Core Operating Limits Report

Braidwood Unit 2, Cycle 9A, Sequence Number 1

TODI No. NFM0100053
 Seq. No. 1
 Page 1 of 14

Subject Braidwood Unit 2 Cycle 9A Core Operating Limits Report in ITS Format and W(z) Function

Figure 2.5.1:
Control Bank Insertion-Limits Versus Percent Rated Thermal Power

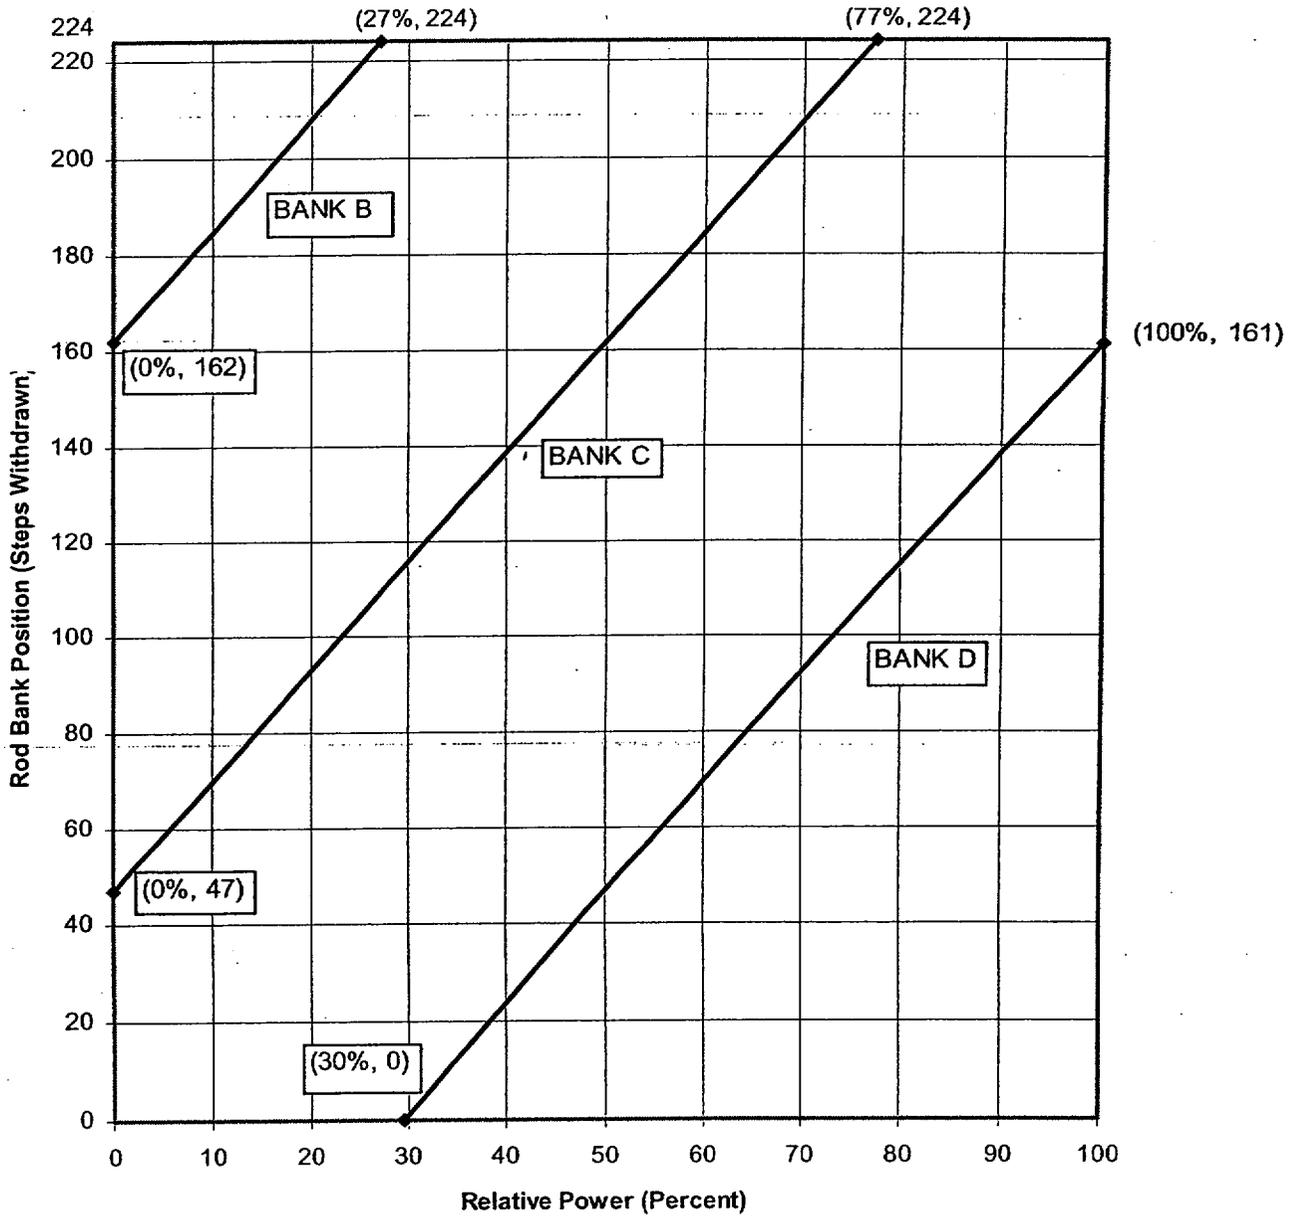
The attached Core Operating Limits Report (COLR) for Braidwood Station Unit 2 Cycle 9A, with uprate values, has been prepared in accordance with the requirements of Technical Specification 5.6.5 (ITS). In this sequence, the following COLR Sections were revised:

- Section 2.2.2; the SDM limits for MODE 5, applicable for LCO 3.1.1,
- Section 2.3.4, the EOL/ARO/HFP-MTC Surveillance limit at 60 ppm, applicable for LCO 3.1.3,
- Section 2.5.1, the control bank insertion limits, applicable for LCO 3.1.6.
- Section 2.5.4, the control bank overlap limits, applicable for LCO 3.1.6.
- Section 2.13.2, the Reactor Coolant System boron concentration, applicable to TLCO 3.1.k.2)

2.5.1 The control banks, with the Bank A greater than or equal to 224 steps, shall be limited in physical insertion as shown in Figure 2.5.1.
